Dunkin

Donuts/Valvoline

20290 GRANDE OAK SHOPPES BOULEVARD

# Site Plan Changes per DRB Conditions of Approval

# Site Plan

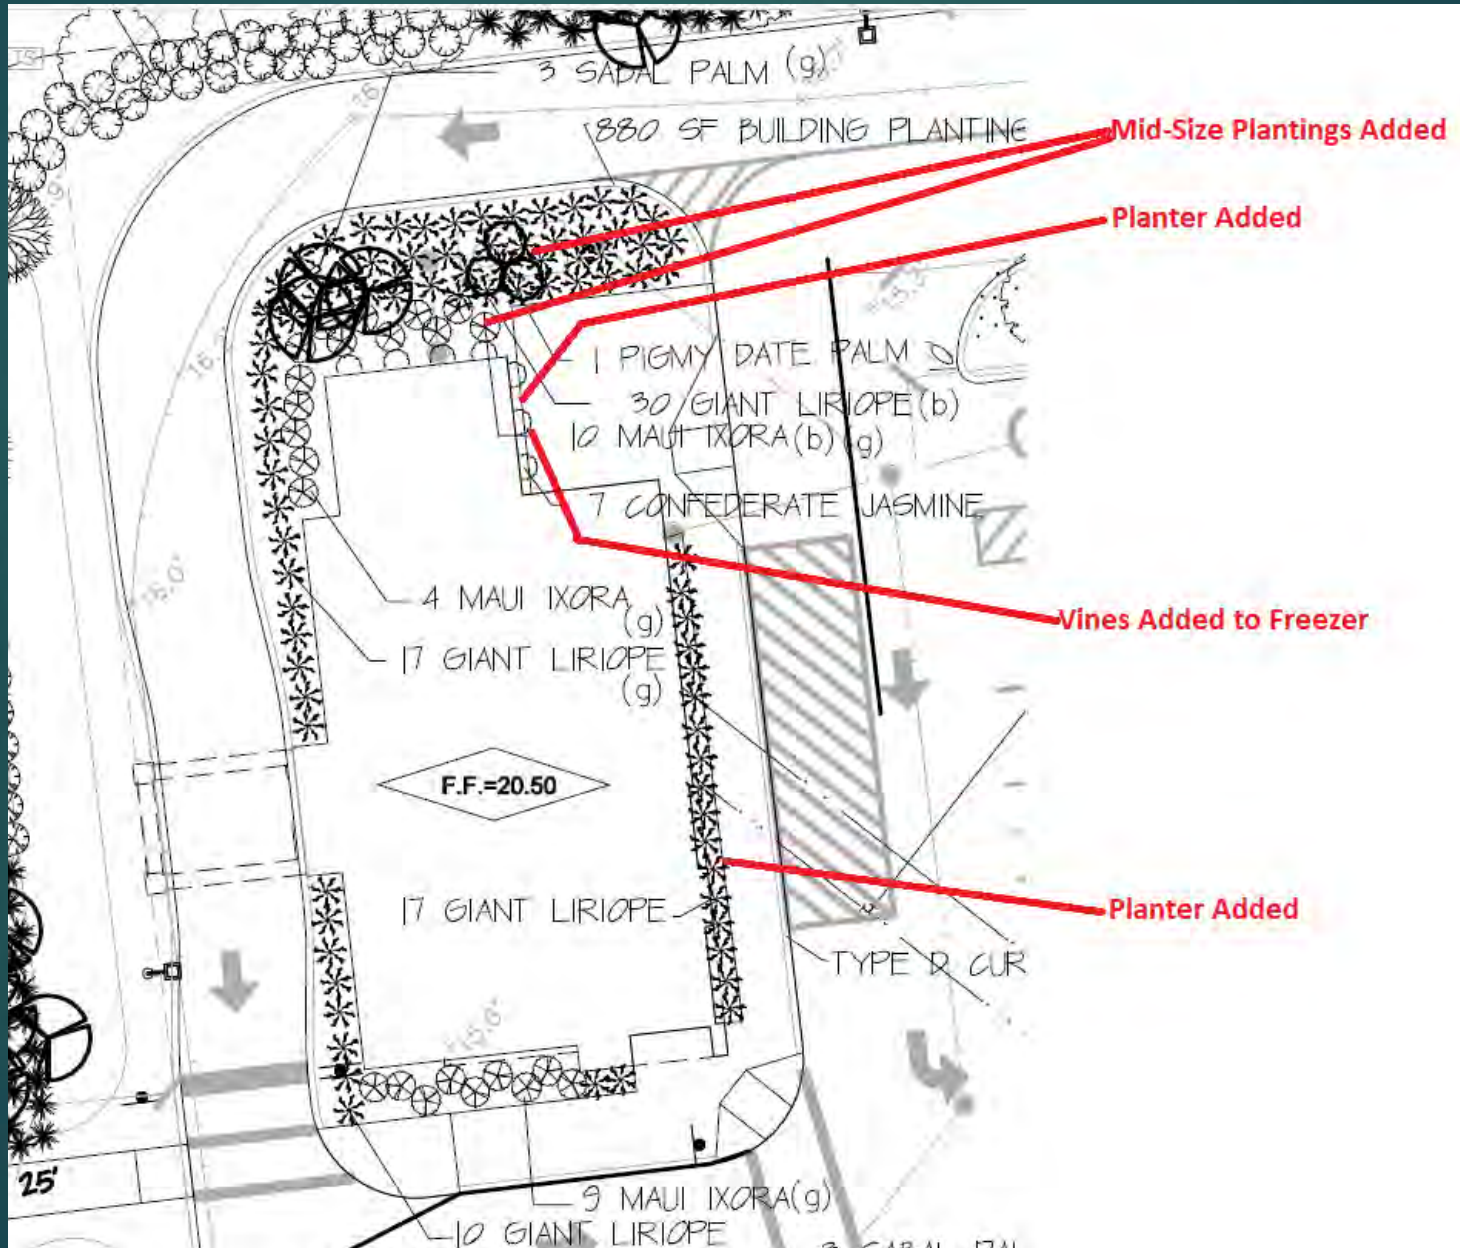
- ▶ Added 1' Wide Planter to East Side of Dunkin Donuts Freezer to provide additional landscape screening
- ▶ Added note for Valvoline Dumpster to be screened with an 8' high enclosure (will include door and will be identical in design to Dunkin Donuts Dumpster Enclosure)

# Landscape Plan

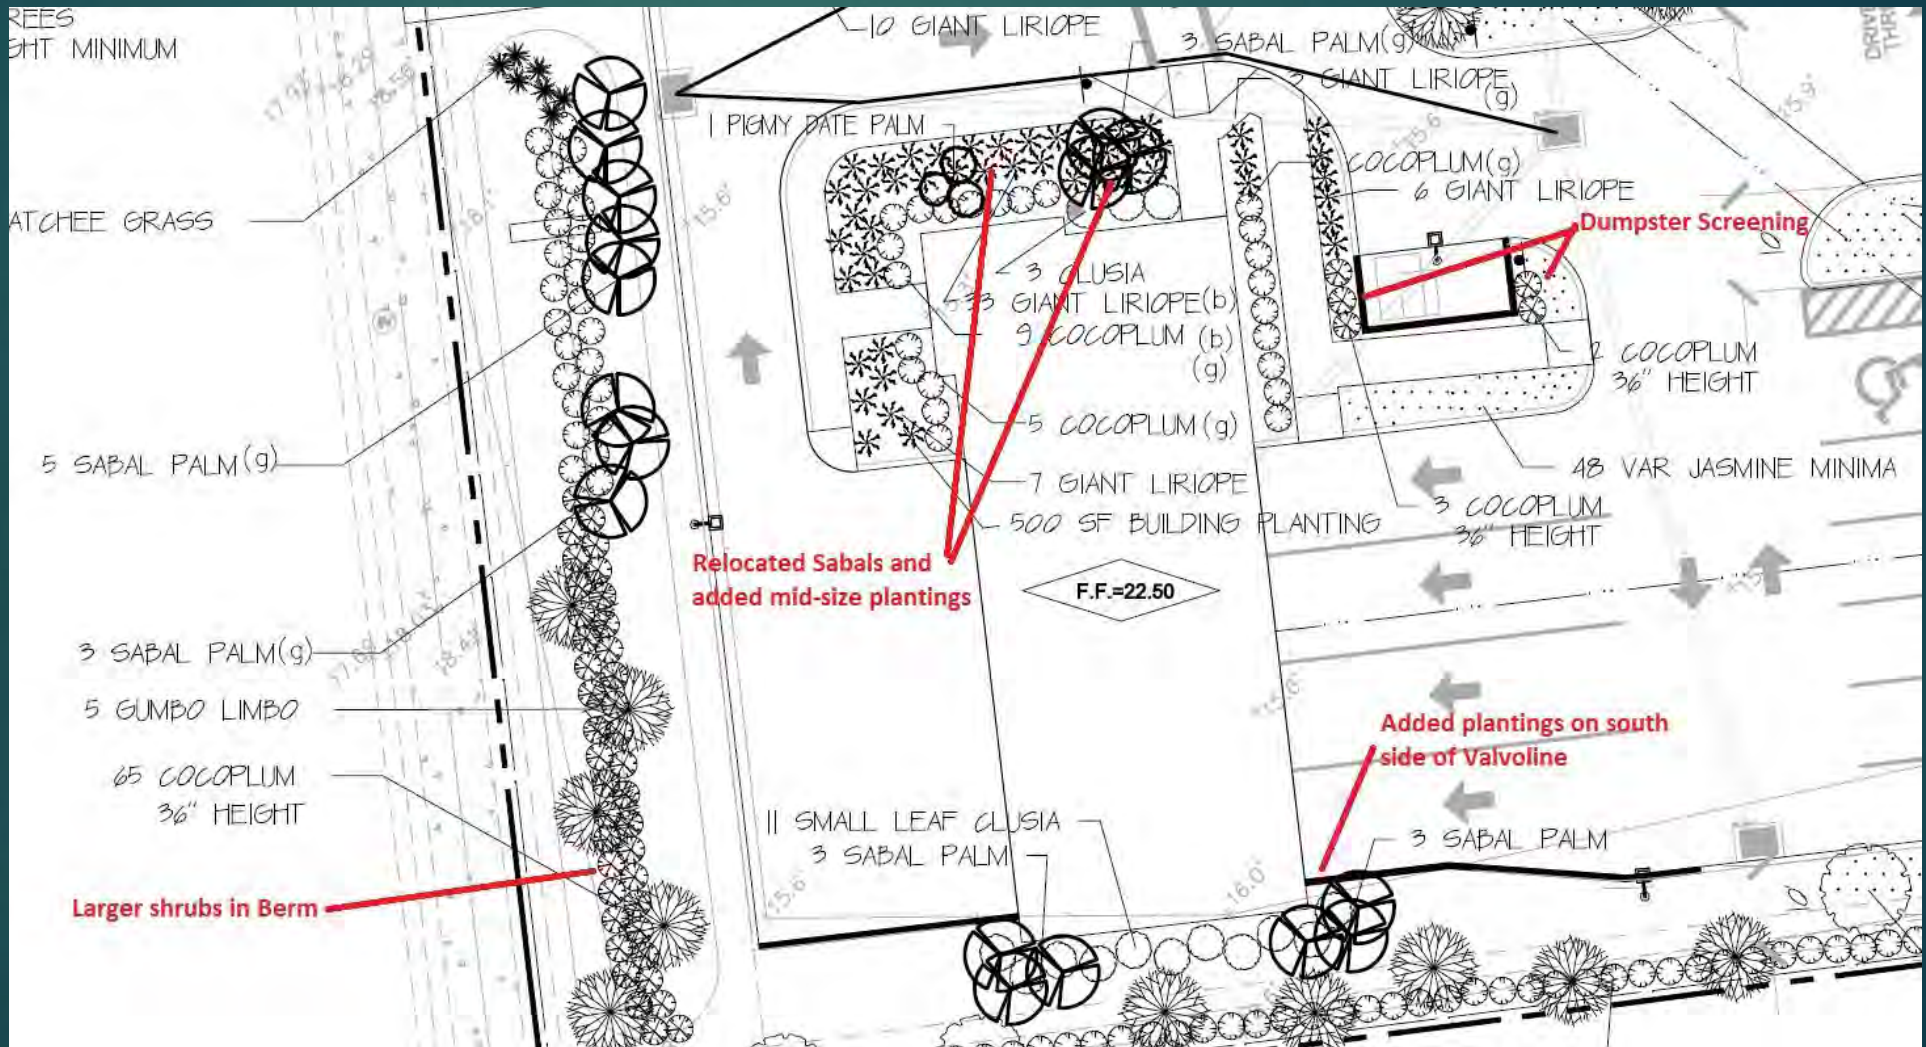
- ▶ Added Vines on Dunkin Donuts Freezer
- ▶ Added mid-sized plantings in area adjacent to freezer
- ▶ Added more large size shrubs to the berm adjacent to Valvoline. Moved the shrubs towards the top of the berm.
- ▶ Planter added on east side of Dunkin Donuts building to provide building buffer between building and parking/sidewalk
- ▶ Added plantings on the south side of Valvoline
- ▶ Added screening to the dumpster by Valvoline
- ▶ Moved the Sabal Palms on the north side of Valvoline and added mid size planting in the planting bed.

# Dunkin Elevations

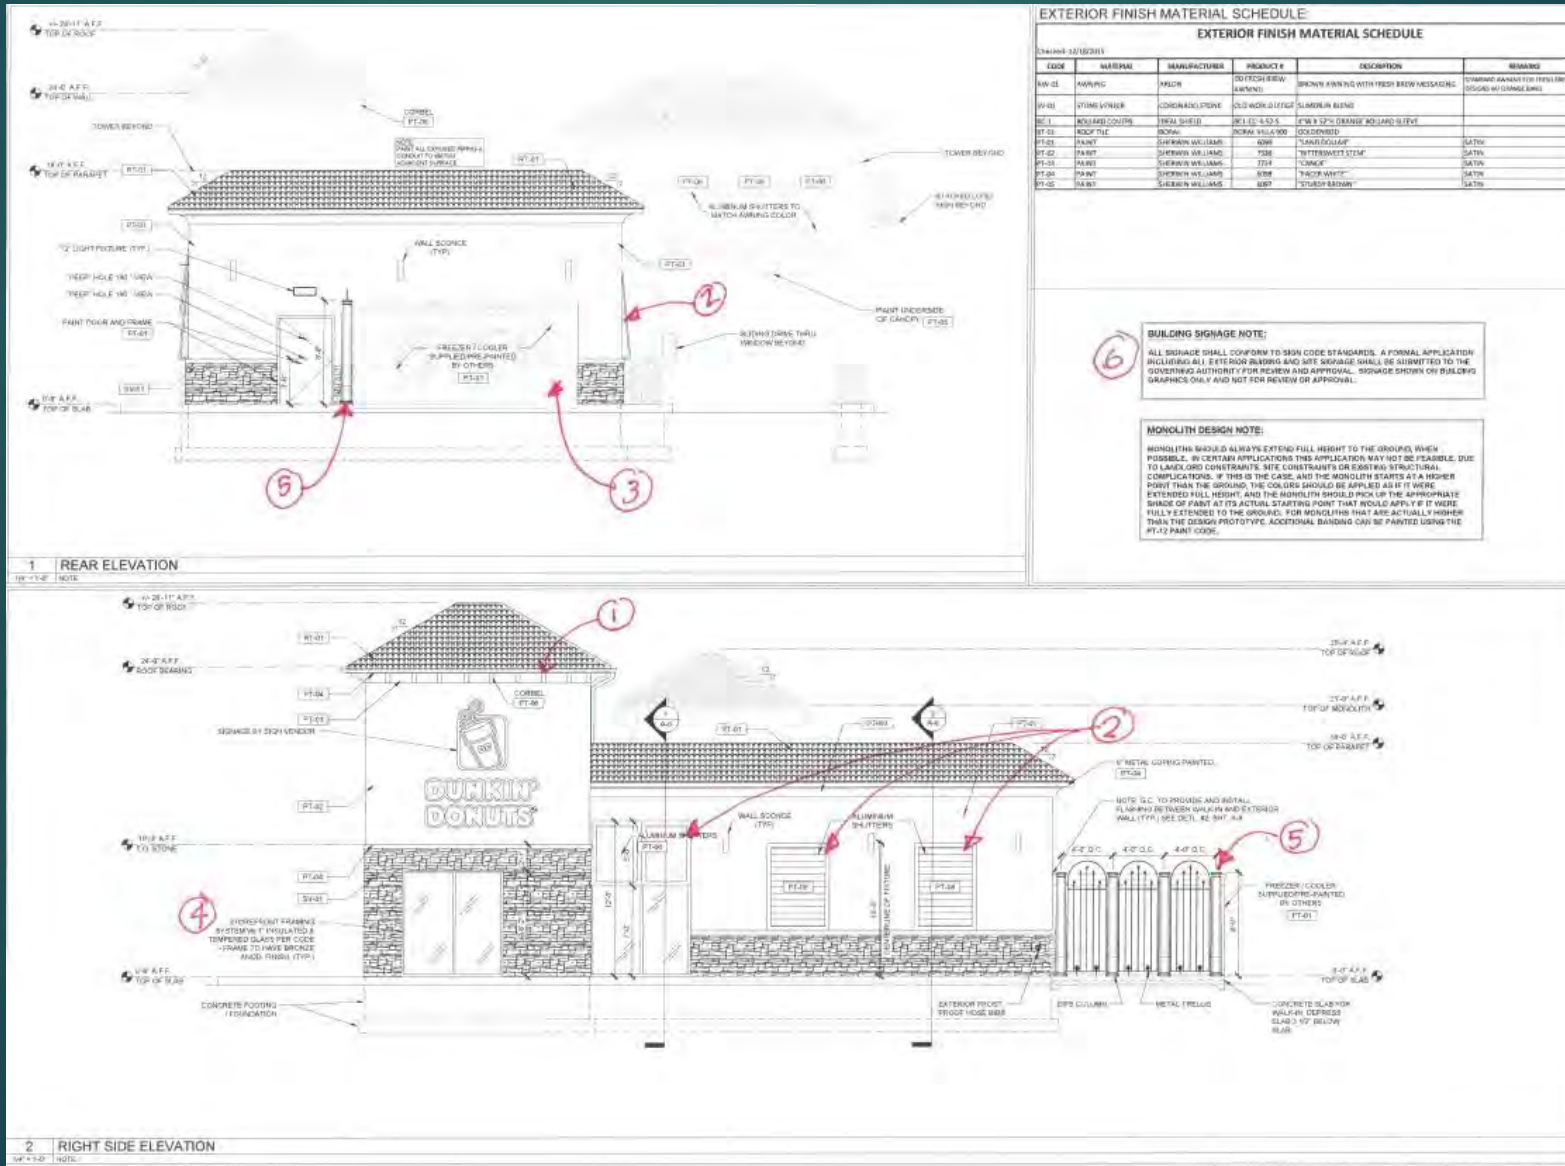
- ▶ Add corbels on tower elements (1)
- ▶ Extend height of awnings on all windows (2)
- ▶ Freezer to have stucco finish and painted to match building (3)
- ▶ Storefront aluminum to be anodized bronze color (4)
- ▶ Provide screen wall at west side of freezer (5)
- ▶ Note added stating that signage will be a separate permit (6)
- ▶ Dumpster Enclosure to be painted to match building (7)
